ERCOT Independent Review of the CenterPoint Jones Creek Project

Version 1.0

Figure 1: Area of Concern

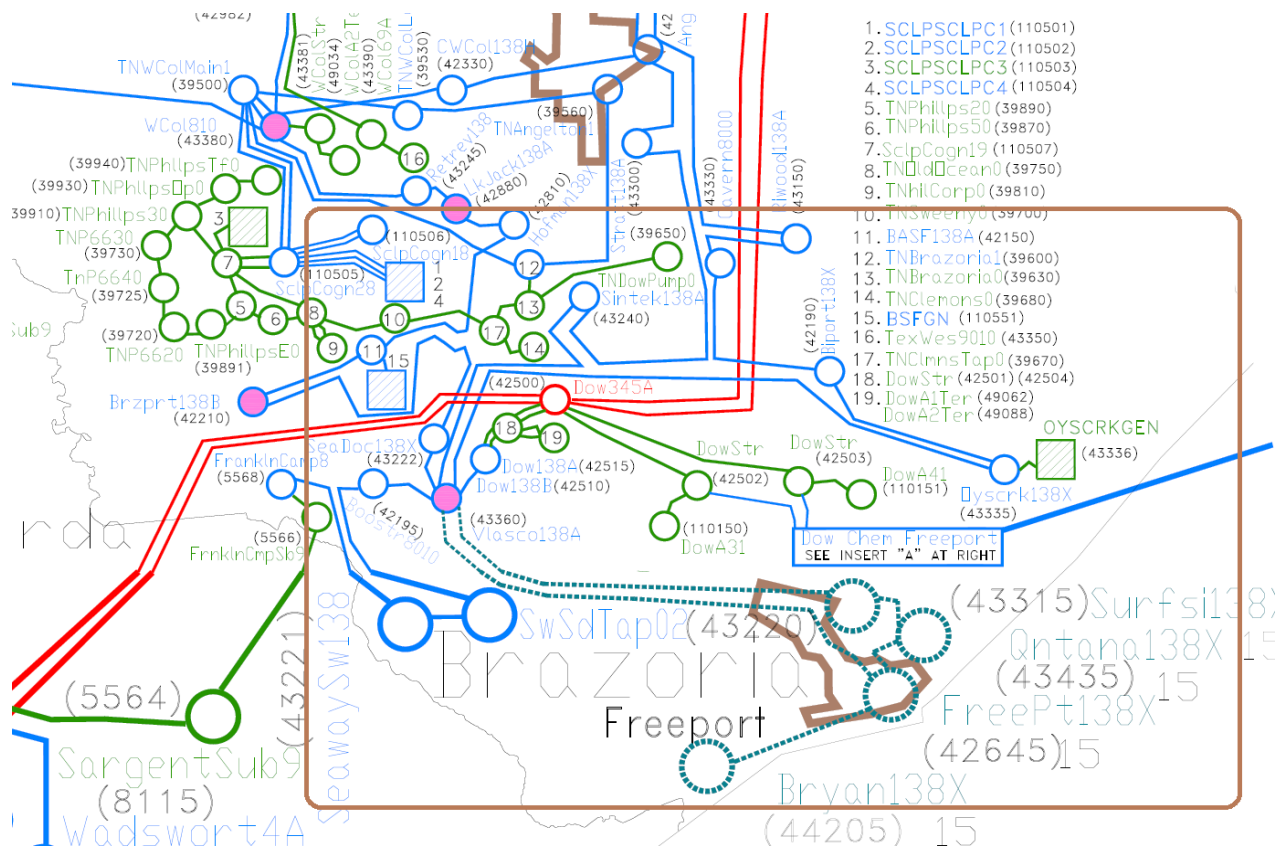
With the above load addition and using the 2019 summer peak load case, under the X-1+N-1 contingencies when both of Dow–Velasco 345/138 kV autotransformers are out of service the case does not solve, which indicates a system voltage collapse. Additionally, several thermal violations around the Freeport area can be observed under certain N-1 or X-1+N-1 contingencies. Figure 1 shows the area of concern.

In order to provide transmission infrastructure that meets ERCOT reliability criteria and serves future load growth in the Freeport area, CenterPoint Energy proposed the following improvements in the area of concern:

- Construct a new 345/138 kV “Jones Creek” Substation;
- Install two new 800 MVA normal rating / 1000 MVA emergency rating (800/1000 MVA) 345/138 kV autotransformers at the Jones Creek Substation;
- Loop the 345 kV Dow - STP circuit 18 into the Jones Creek Substation;

- Loop the 138 kV Freeport - Velasco circuit 59 into the Jones Creek Substation;
- Upgrade the Velasco 138 kV Substation to a fault duty rating of 63 kA;
- Split and reconfigure circuits in the Freeport area creating: 138 kV Velasco - Surfside - Freeport - Jones Creek circuit 59, 138 kV Velasco - Quintana - Jones Creek circuit 48, and 138 kV Velasco - Jones Creek circuit 59;
- Reconfigure 138 kV Velasco - Franklins Camp circuit 02 to create 138 kV Jones Creek - Franklins Camp circuit 02;
- Upgrade the 138 kV Jones Creek - Quintana circuit 48 and 138 kV Quintana - Velasco circuit 48 with 838 MVA normal rating / 894 MVA emergency rating (838/894 MVA);
- Install a new 138 kV 120 MVAR capacitor bank at the Jones Creek Substation.
